STATE OF HAWAII DEPARTMENT OF TRANSPORTATION HIGHWAYS DIVISION MECHANICALLY STABILIZED EARTH RETAINING WALL (MSERW) TYPICAL SECTION AND DETAILS KAHKILI HIGHWAY WIDENING Likelike Hwy. to Vicinity of Haiku Road F.A. PROJECT NO. NH-083-1(26) SCALE: AS NOTED DATE: APRIL 1994 SHEET No. W1 OF W21 SHEETS	
--	--

AS-BUILT ADD. 114

KAHEKILI HIGHWAY WIDENING
Likelike Hwy. to Vicinity of Haiku Road
F.A. PROJECT NO. NH-083-1(26)

STATE OF HAWAII DEPARTMENT OF TRANSPORTATION HIGHWAYS DIVISION	
PLAN AND PROFILE R.C. WALL NO. 1 AND NO. 1B	
KAHEKILI HIGHWAY WIDENING Likelike Hwy. to Vicinity of Haiku Road F.A. PROJECT NO. NH-083-1(26)	
SCALE: AS NOTED	DATE: APRIL 1994
SHEET No. W8B OF W21 SHEETS

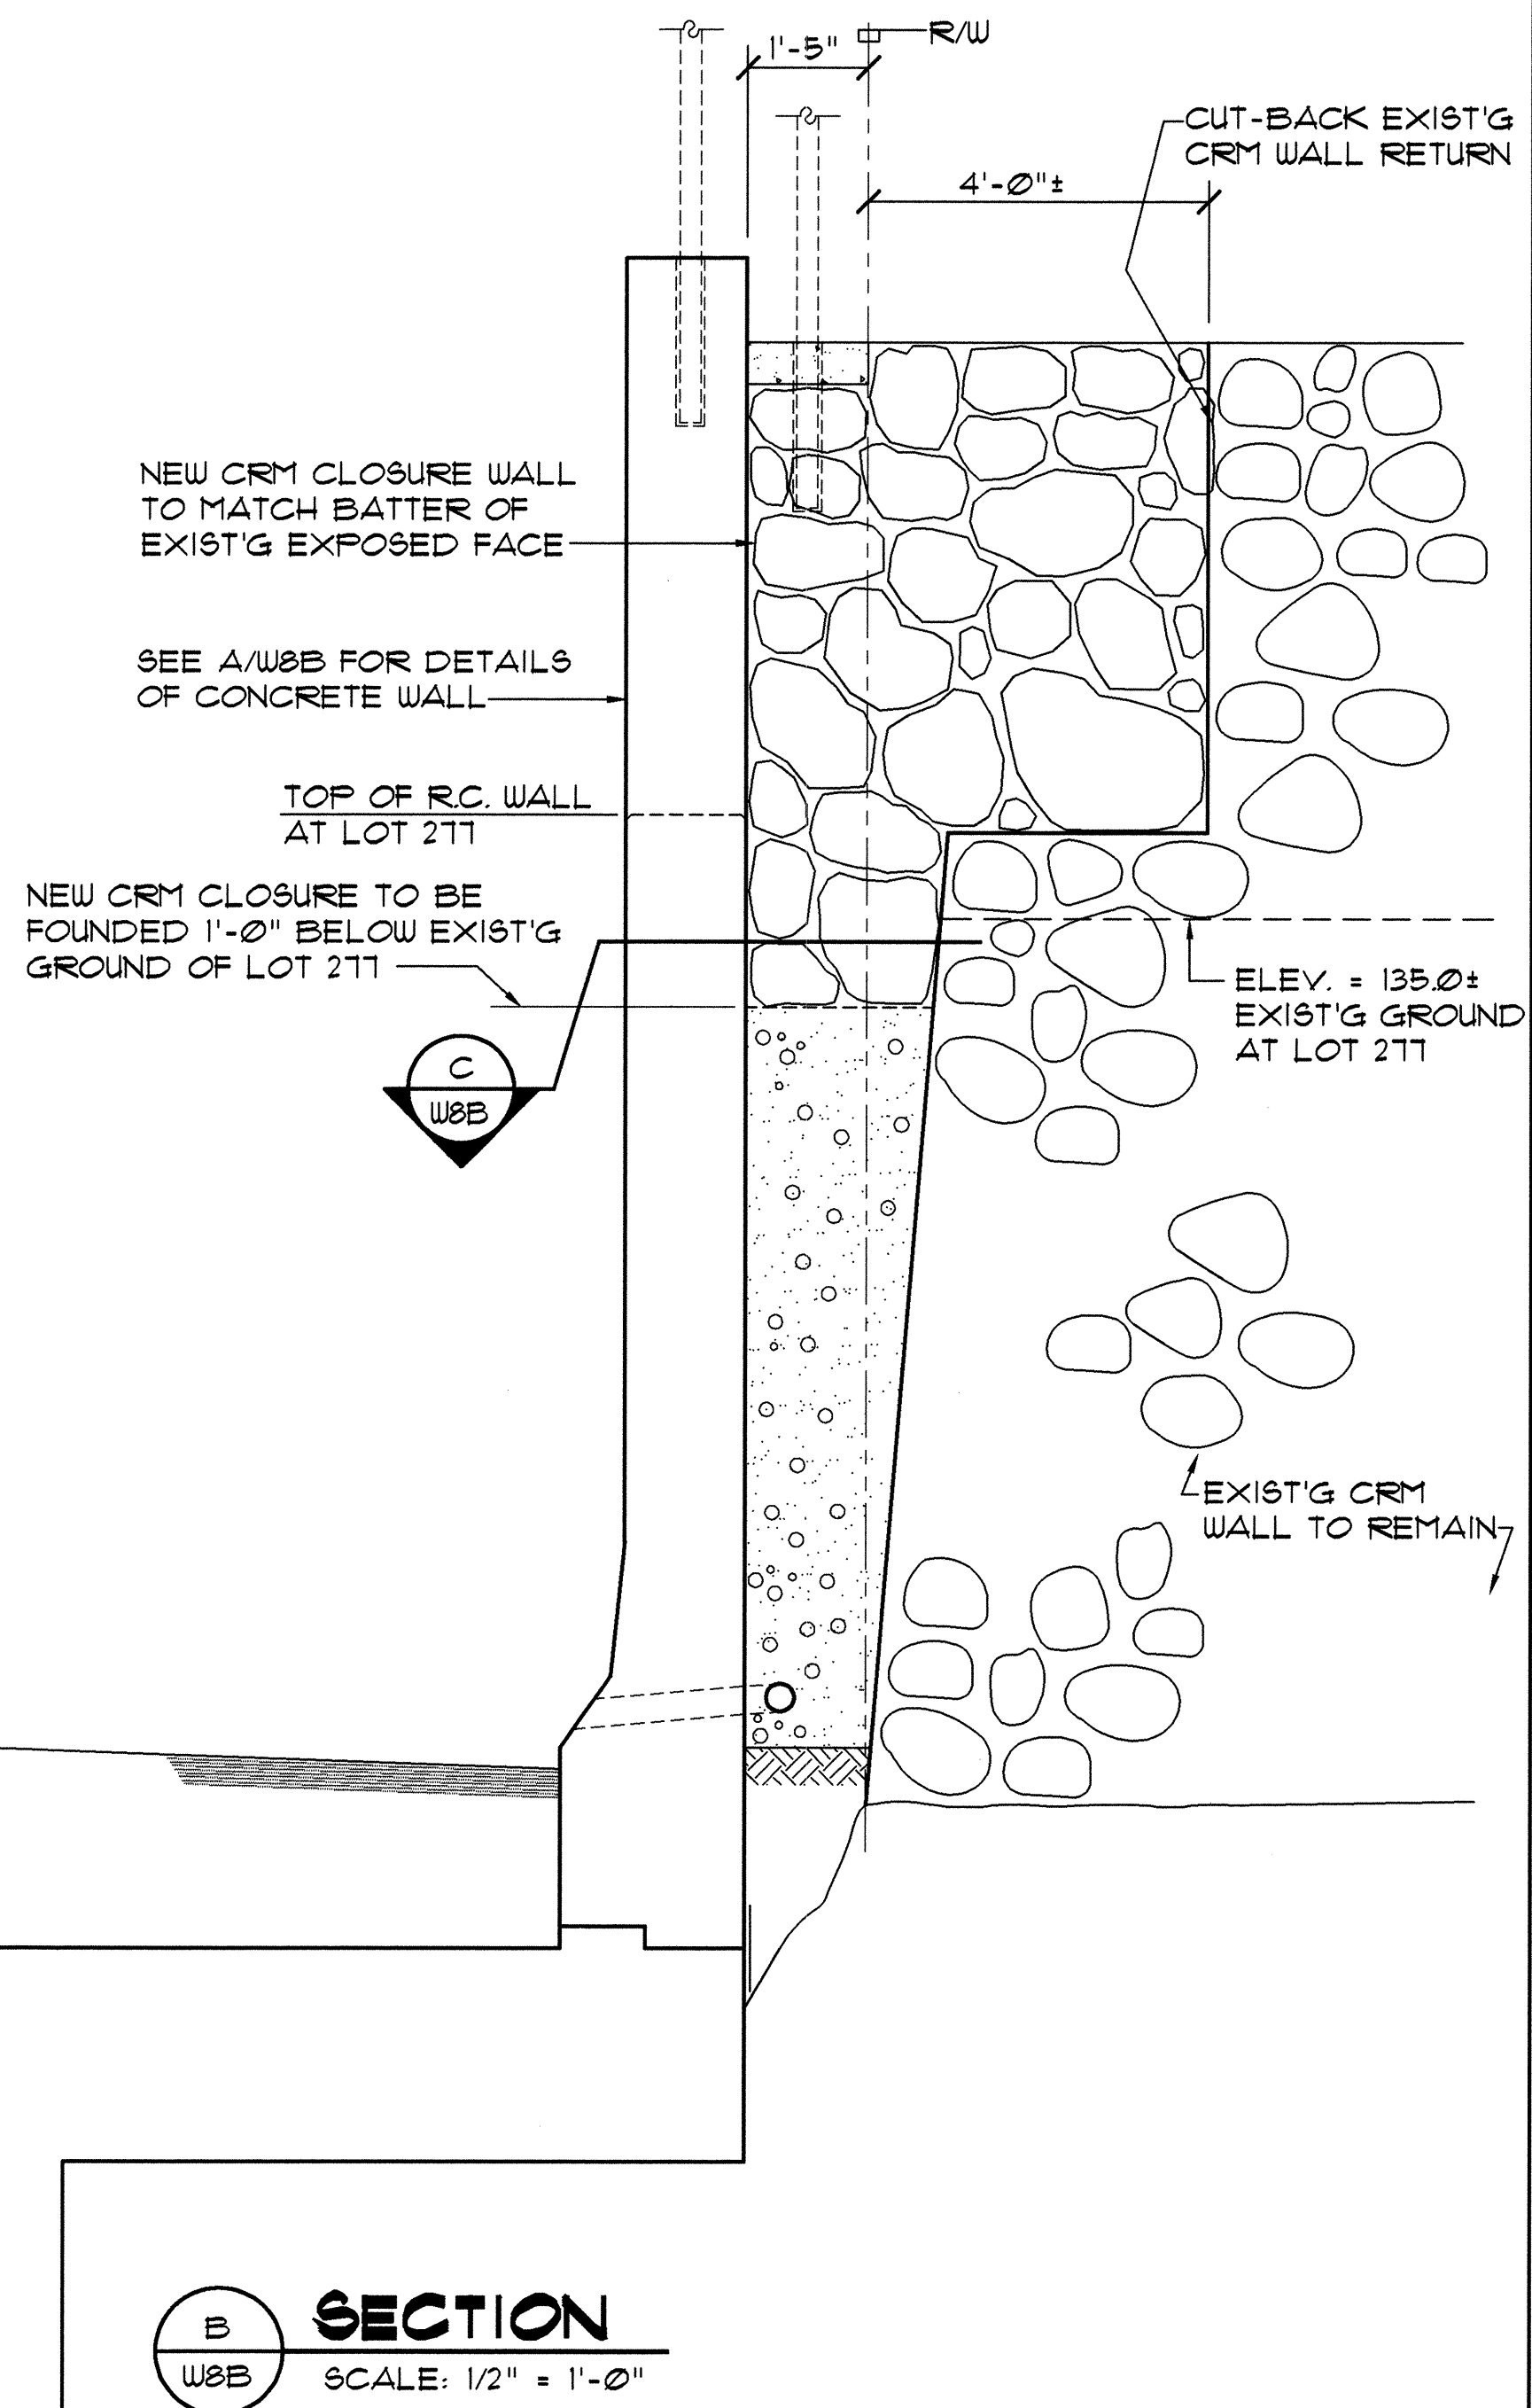
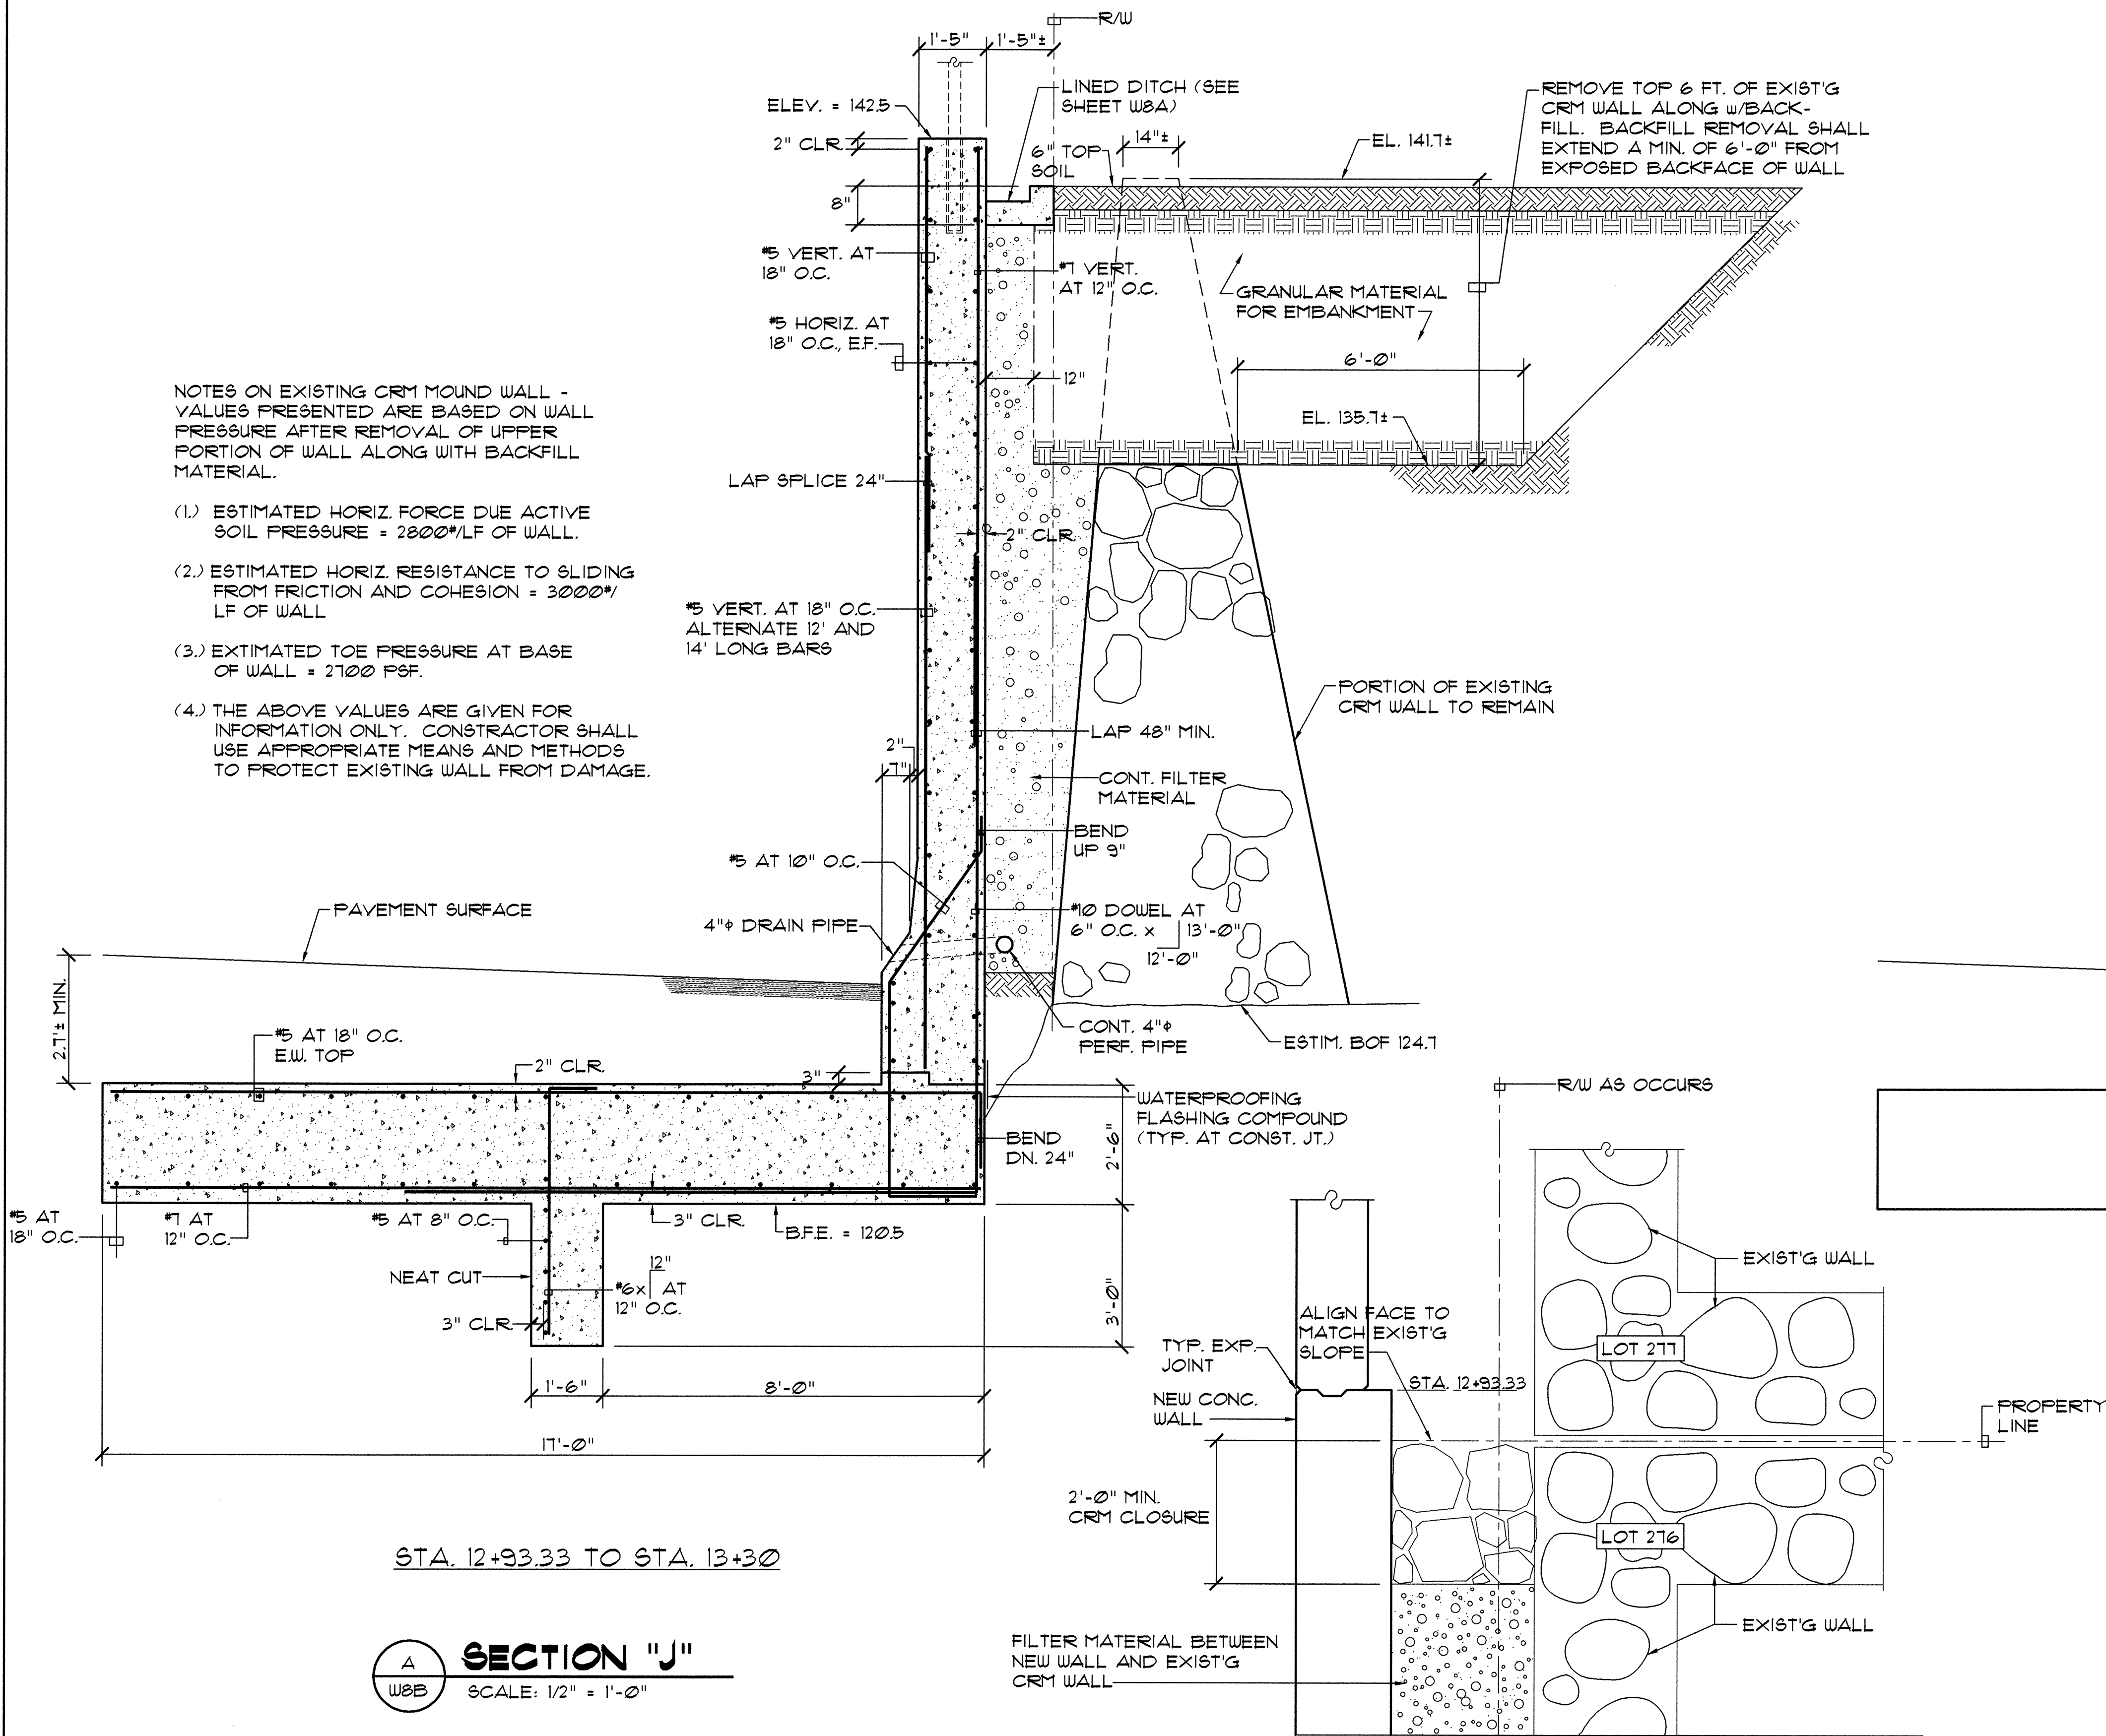
10/1/96	REVISED RETAINING WALL SECTION FROM STA. 12 + 93.33 TO 13 + 90
DATE	REVISION

PLAN AND PROFILE
R. C. WALL NO. 2, 2A AND 2B

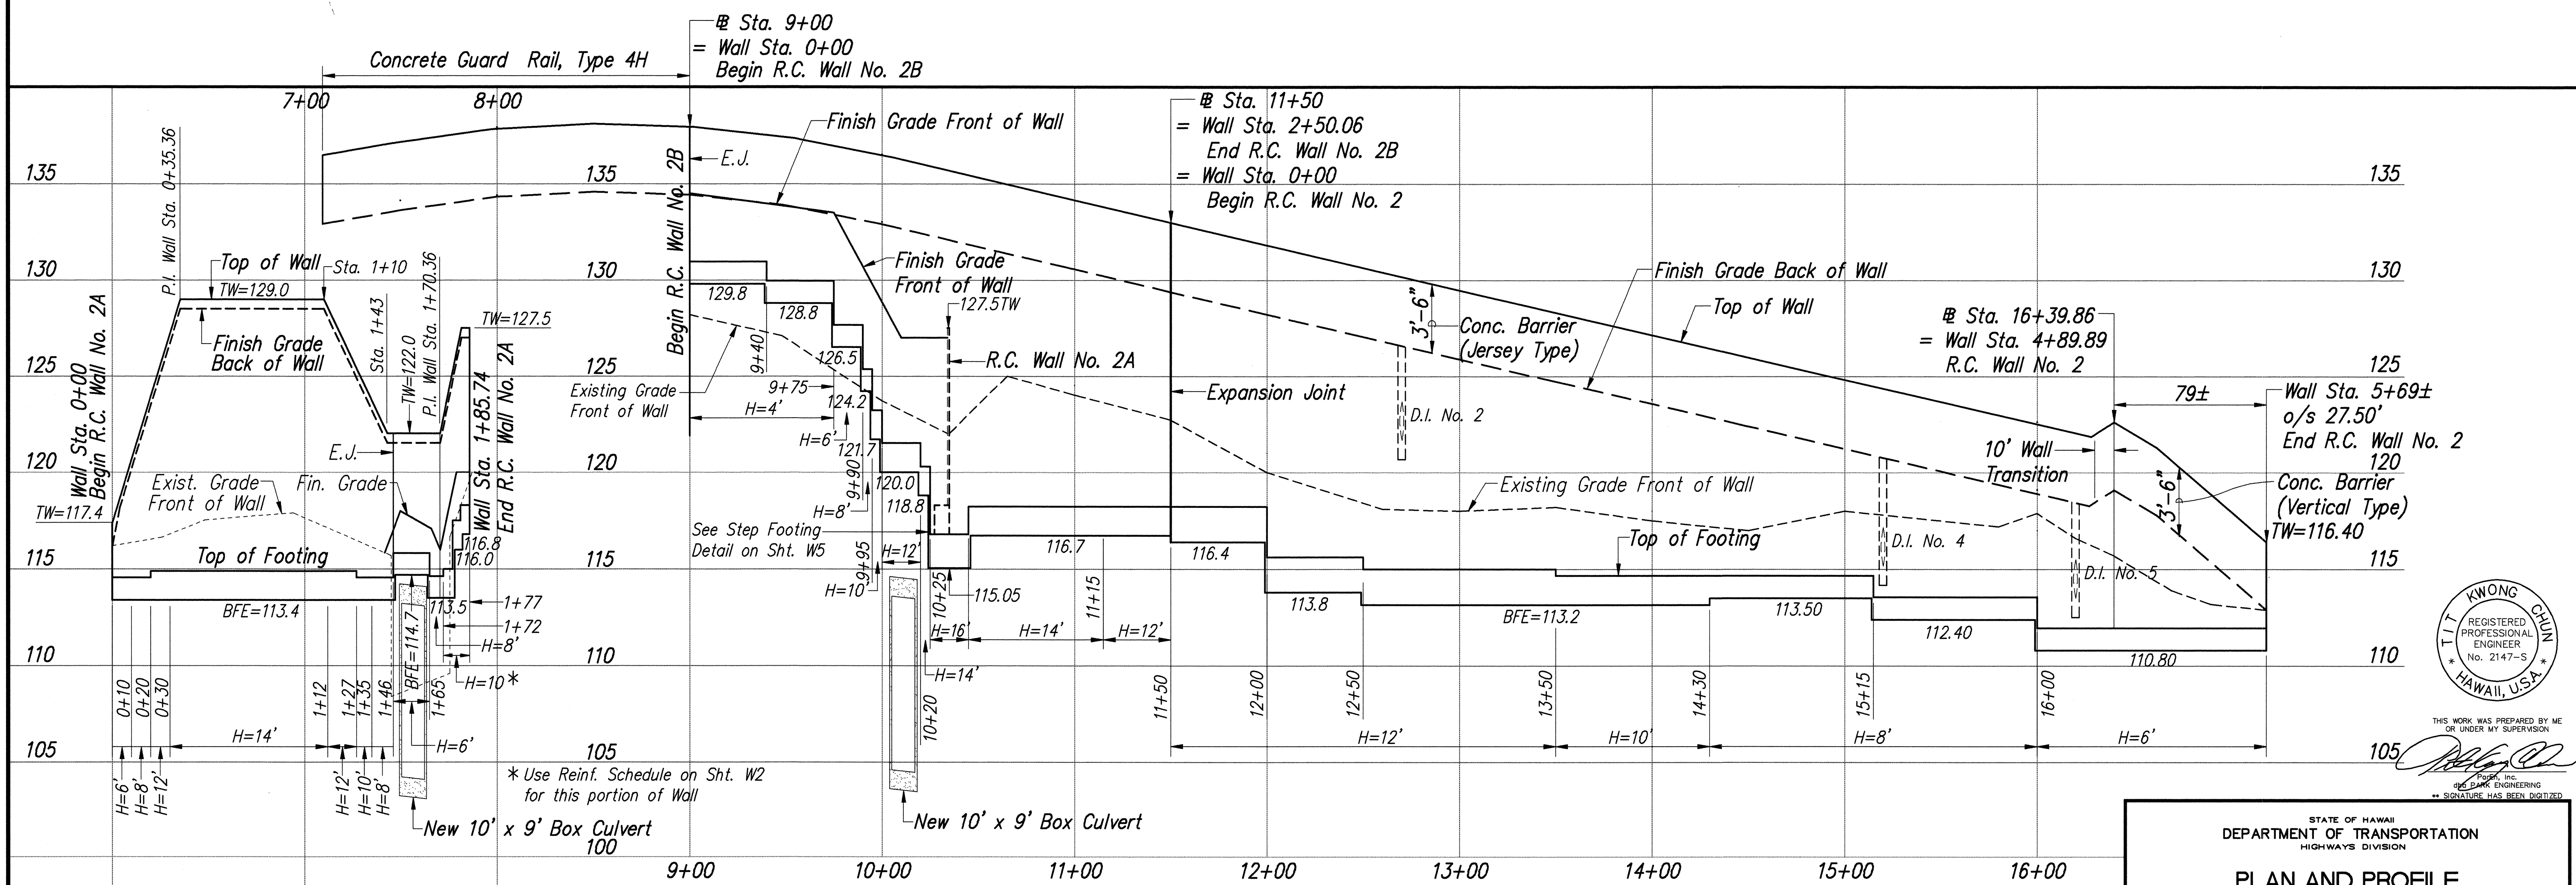
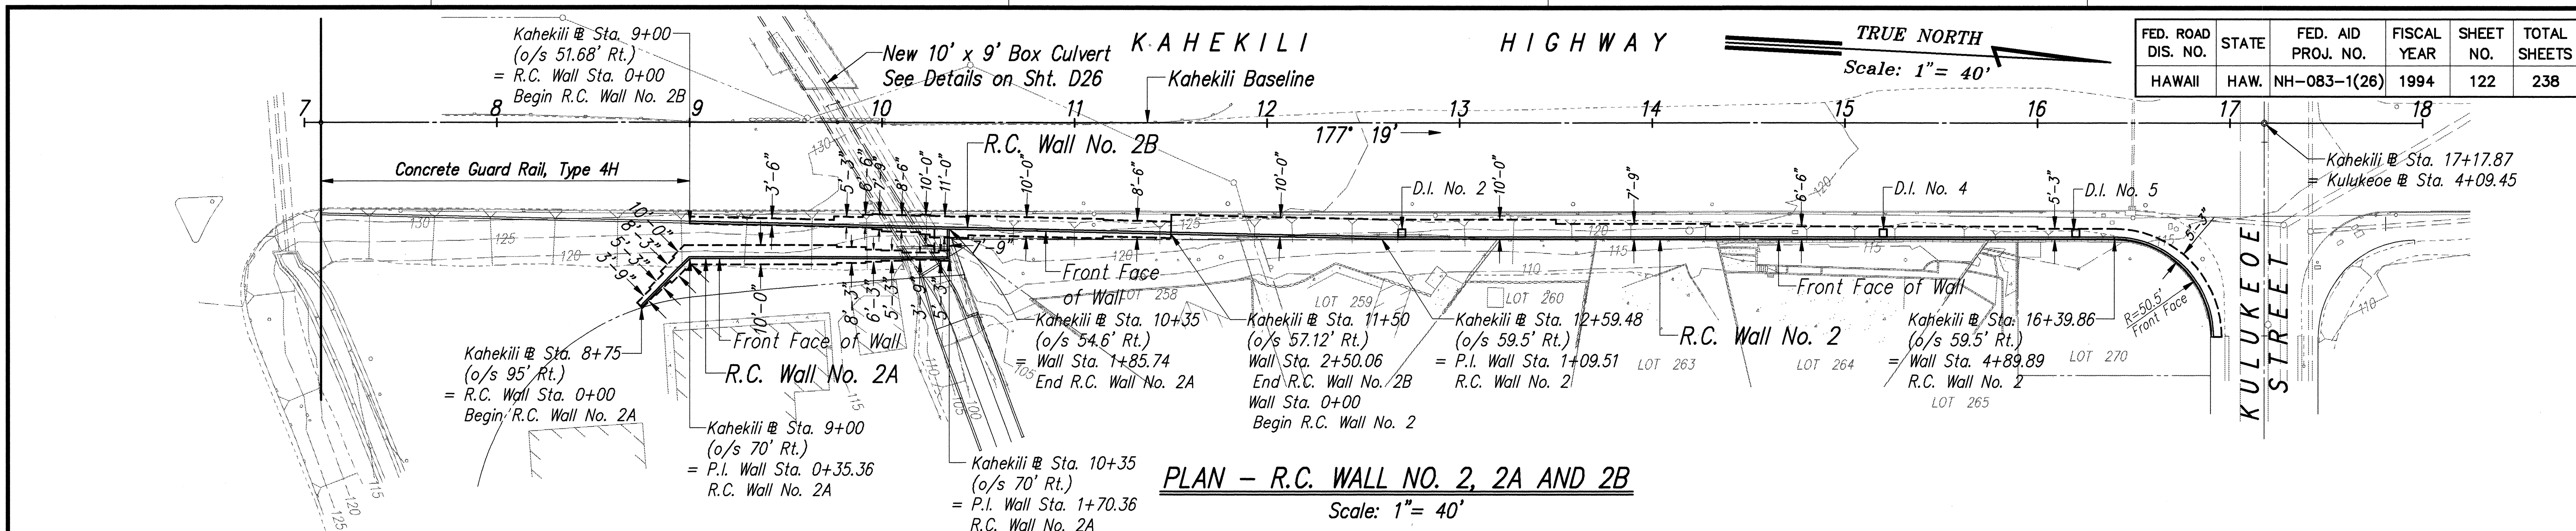
DATE		REVISION	
9/04/96		REVISED FOOTING ELEVATION FOR R.C. WALL NO. 2 BETWEEN STA. 15+25 TO STA. 16+60
